Re: Turkey Point Units 3 and 4
Docket Nos. 50-250 and 50-251
Emergency Plan Implementing Procedure Changes

The following Emergency Plan Implementing Procedures have been revised:

SUMMMARY OF CHANGES

Operations Support Center (OSC) Activation and Operation

TYPICAL OSC LAYOUT

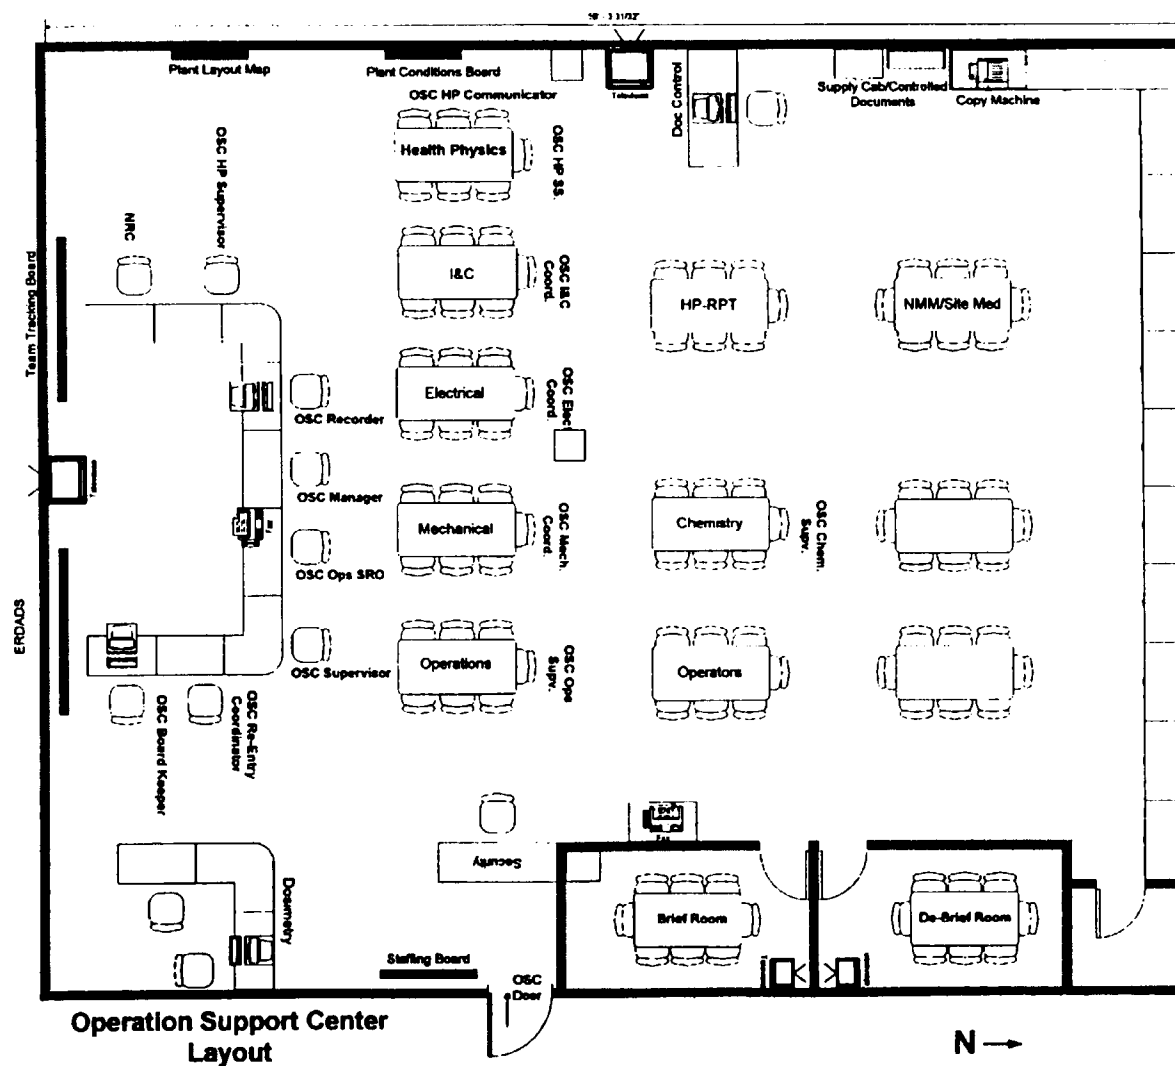
1. Move all OSC responder required activities from section 5 to their respective sign-off attachments.
2. Add guidance to section 5 for responders to obtain their sign-off attachment.
3. Delete the OSC Plant Status Board position, and add those individuals to Status Board Keeper position.
4. Delete the OSC Team Status Board position, and add those individuals to Status Board Keeper position.
5. Add sign-off section for each OSC responder: Attachments 5 thru 24.
6. Change OSC Layout.

Changes 1, 2, and 5 are format only. Each sign-off attachment will help ensure that each responder's required activities are complete and documented. Changes 3 and 4 combine both of the OSC Status Board Keepers into one position. Although the two positions are now incorporated into one, the utilization of new computers and projector will enable one person to accomplish both tasks. With Change 6, the OSC has now become a dedicated facility. There have been enhancements made to the facility such as Briefing and De-Briefing rooms, new furniture, new phones, computers, and projectors. The OSC facility is permanently set up and in ready status. Since the facility is now dedicated, there is no longer a need to set up the facility during activation.
